Technical Service Bulletin

NO COOL AIR FROM AIR CONDITIONER (LEAK FROM EVAPORATOR)

Bulletin No.: 07-005/19

Last Issued: 09/10/2019

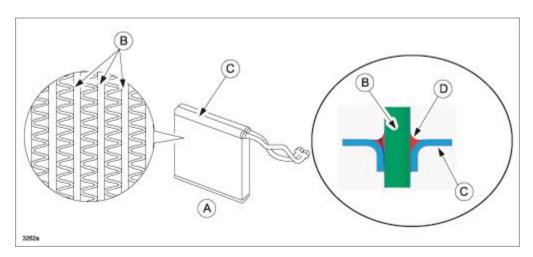
Some customers may complain about no cool air from the vents when the air conditioner (A/C) is ON. This concern may be caused by A/C refrigerant leaking from the evaporator (A) at the joint between the tubes (B) and the header (C) due to improper brazing (D). To correct the problem, the configuration of the header has been changed to improve the brazing performance in this area.
